Staff Report
City of Richmond, Virginia

Commission of Architectural Review

6. COA-117377-2022	Final Review	Meeting Date: 9/27/2022
Applicant/Petitioner	Joseph Yates	
Project Description	Construct a new two-story rear addition.	
Project Location		
Address: 516 N. 26 th Street		
Historic District: Church Hill North		
High-Level Details: <ul style="list-style-type: none"> The applicant requests approval to rehabilitate the exterior of a circa 1920 frame dwelling and to construct a two story rear addition. Exterior rehabilitation includes removing existing vinyl siding, and posts, and restoring/replacing in-kind with wood posts and wood siding. Fiber cement siding will be installed on minimally visible elevations. Vinyl windows will be removed and replaced with aluminum clad wood windows. Damaged/deteriorated wooden elements such as the cornice, molding, trim, and sills will be repaired/ replaced in-kind. The applicant proposes to remove a deteriorated, one-story projection from the rear and to construct a two-story rear addition and covered porch. The addition will be as tall as the existing dwelling, and will have a gable roof form, cementitious siding, and aluminum clad wood windo

Figure 2. Photo approx. 1954

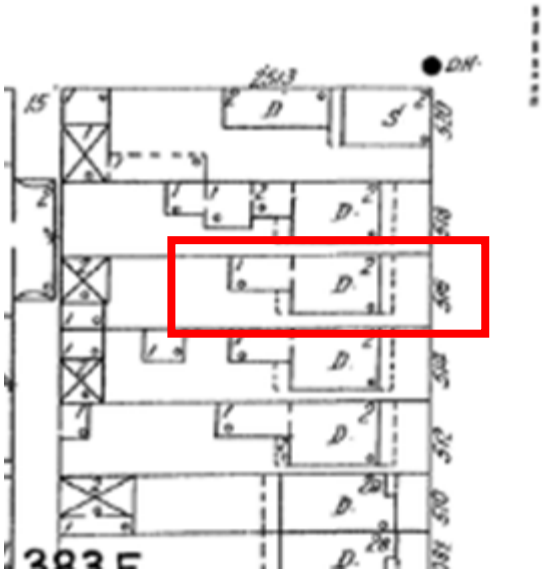
<p>additional weight of a second-story addition without significant repair. The report recommends that the footings of the addition be resized to support the new addition. Due to physical site constraints, this repair would be difficult.</p> <p>The new addition would be approximately 10 feet longer than the existing rear projection, and will be lower in height than the historic portion of the dwelling. With the new addition, the dwelling be approximately 60' in length, not including the 12' deep rear covered porch.</p> <p>The new construction located to the south at 514 N 26th Street, and the historic dwelling located at 512 N. 26th Street are both approximately 60' in length. Staff finds that there is precedent on the subject block for the proposed length of the dwelling with the new addition.</p>
Materials, #1, p. 47	<i>Additions should not obscure or destroy original architectural elements.</i>	<p>The proposed addition will obscure the original second-story, rear façade of the existing dwelling.</p> <p>The addition will not affect the front façade of the dwelling. The applicant is proposing to rehabilitate the front façade to match the historic image from the 1950's which shows many of the original architectural elements which are no longer present such as a decorative cornice, brackets, double door at the primary entrance, 2/2 windows, and sawn pickets.</p>
